Docket Number:	08-AFC-08A
Project Title:	Hydrogen Energy Center Application for Certification Amendment
TN #:	200767
Document Title:	Additional Information Requested in the PSA/DEIS Provided by Occidental of Elk Hills
Description:	N/A
Filer:	URS
Organization:	URS Corporation
Submitter Role:	Applicant Consultant
Submission Date:	10/7/2013 4:14:16 PM
Docketed Date:	10/7/2013

Additional Information Requested in the PSA/FEIS 9-30-13
Provided by Occidental of Elk Hills, INC.

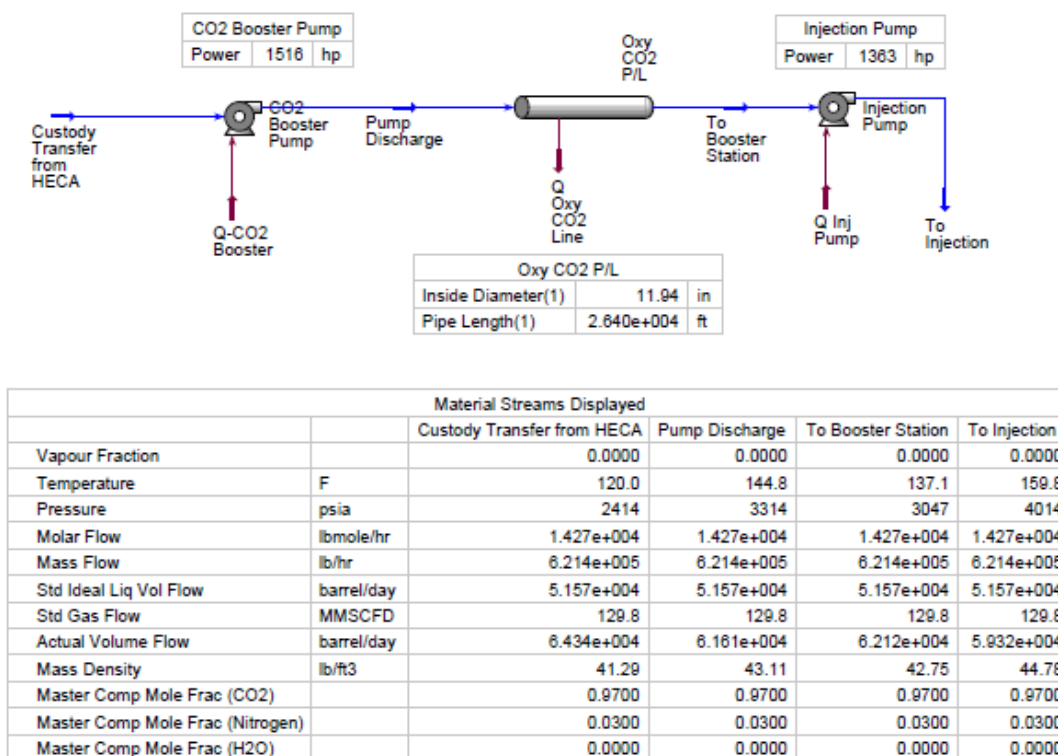
- J. The applicant stated that the power consumption for initial CO₂ compression that is completed at the HECA site was sufficient to provide CO₂ at a pressure necessary for geologic sequestration.
 - Please confirm that means that the compression completed at the HECA site and the power consumed by the compressors on the HECA site is adequate to provide a level of compression that is sufficient to provide pressure necessary for geologic sequestration, or if the power consumption calculations include additional compression power consumption beyond that which is actually done at the HECA site that would be needed to obtain the desired pressure.

Response: Additional compression is required, above that supplied by HECA, to inject CO₂ into the target geologic formation. The document below (provided on June 27, 2013) summarizes power requirements for the additional compression.
